## **City of Bozeman - Response Letter**

FROM: MFGR DESIGNS

RE: SIX RANGE CONDOMINIUMS SITE PLAN, APPLICATION 21235 COMMENTS

DATE: 01/10/2022

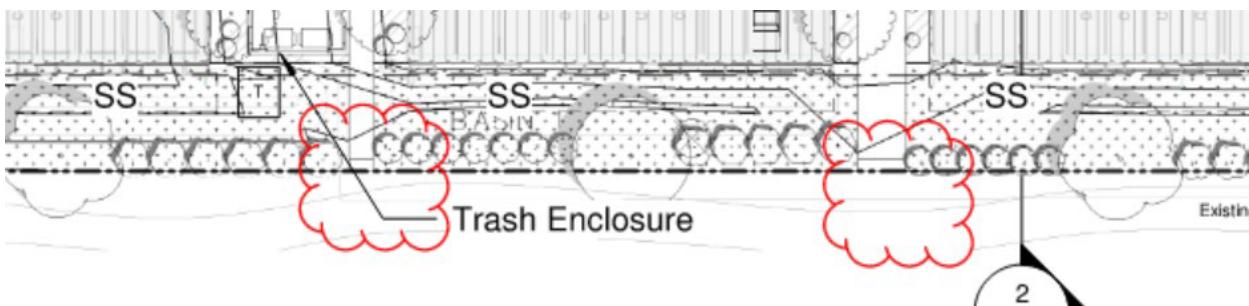
- e. Sidewalk adjacent to townhomes needs to be at least 5' wide per BMC 38.520.040.D.1, and the landscaping needs to meet the special residential block frontage with at least 10' landscaping.

- i. Sidewalks adjacent to townhomes are now 5' wide with 10' of landscaping. (See Site Plan)
8. BMC 38.520.040.C.5 Connections to adjacent properties (including parks and trails). Provide pathways that connect to adjacent properties. **Ensure all north south pedestrian trails shown connect all the way to the adjacent east west trail to the south located off site (see image below of one of the connections that needs to be completed).**

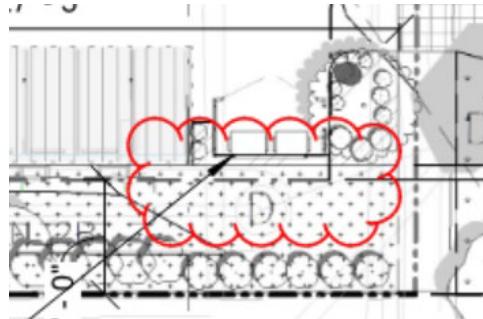
- a. See Sheet A1.22
10. BMC 38.520.070.C.2 The sides and rear of service enclosures must be screened with landscaping at least five feet in locations visible from the street, parking lots, and pathways to soften views of the screening element and add visual interest. **The areas where the trash enclosures backs up to the trail and adjacent properties to the south will require this screening. The image below shows 1 of the 3 enclosures this applies to.**

- a. Plantings have been added as screening on the south faces of trash enclosures and facing pathways. (See Overall Landscape Plan)
11. **BMC 38.520.070.E.** Location and screening of roof mounted mechanical equipment.  
Please indicate if you have any rooftop mechanical equipment, and if so how is it screened? IF not, where is your mechanical equipment located?

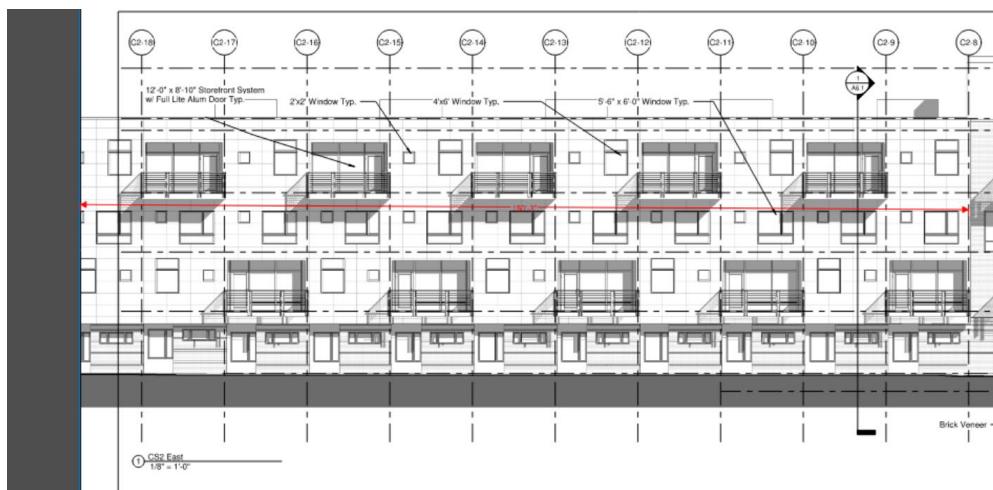
12. **BMC 38.530.040.C.** Façade articulation. Residential buildings must include articulation features at appropriate intervals relative to the scale of the façade in order to reduce the perceived massing of the building and add visual interest. At least three of the following features must be employed at intervals relative to the individual dwelling units or at a maximum of every 30 feet. The scale of the façade articulation should be compatible with the surrounding context. **The larger buildings have sections that require additional articulation.** Currently there is the use of windows and entries, however another articulation method is required. Refer to this code section as to which articulation method would work. This is seen on Sheet A3C2.0 (both west and east facades), A3B1.0 (north and south façade) and A3A1.0 (east and west façade).

- a. The Applicant is requesting a departure from BMC 38.530.040.E. The resubmittal have provided additional rendered perspectives depicting the

variations of the facade. The design has implemented balconies, recessed decks and recessed window openings to provide additional architectural character within the facade. (See A9.01 - A9.15)
